Modification Recommended Service Note

Supersedes:
N4690D-02

N4690D Electronic Calibration Module (ECal)

Serial Numbers: MY57450000- MY59410001

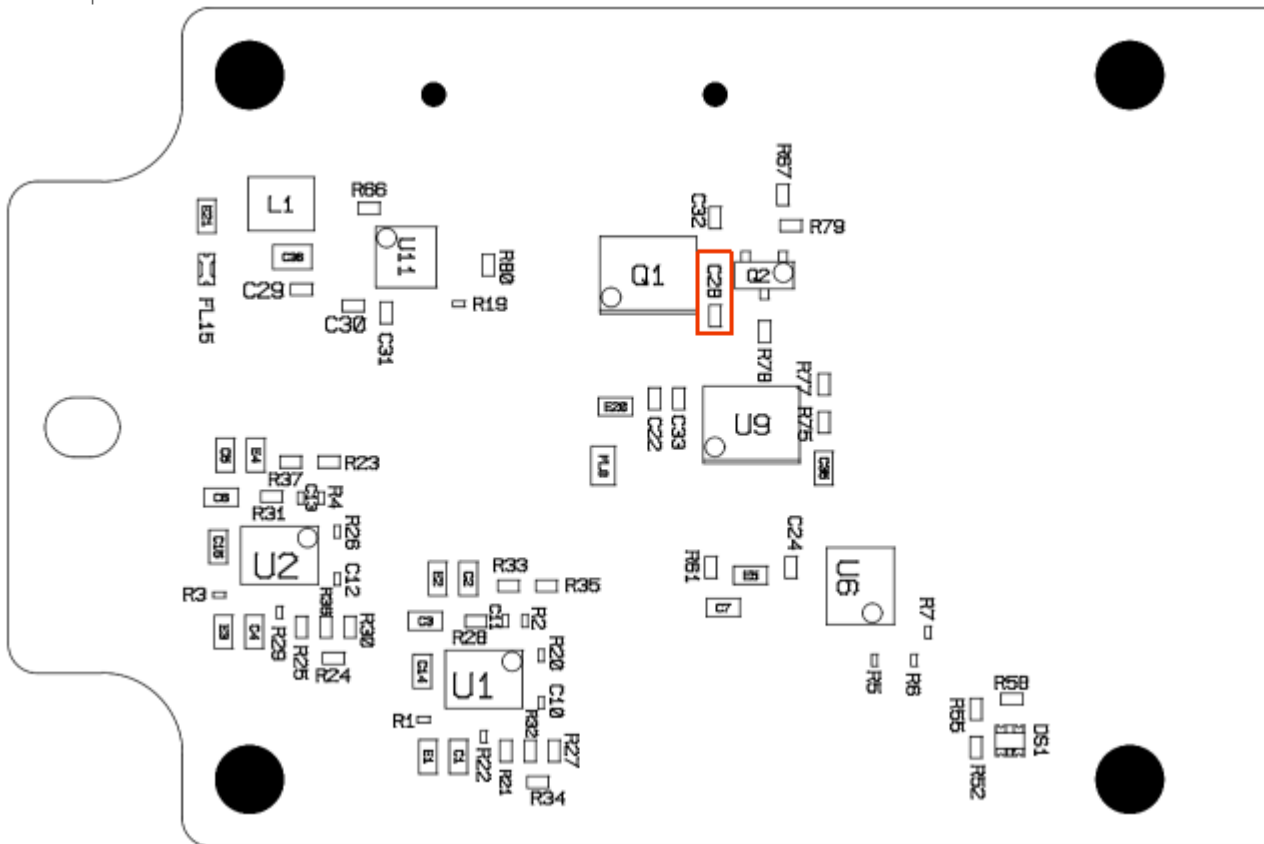
Open the ECal module and remove the N4690-63004 printed circuit board. On this board, locate the C28 capacitor indicated here:

If this capacitor has been removed, no further action is required. Reassemble the ECal module.

If this capacitor exists on this board, this capacitor should be carefully unsoldered and removed, or the N4690-63004 printed circuit assembly should be replaced. Once this is done, reassemble the ECal module.
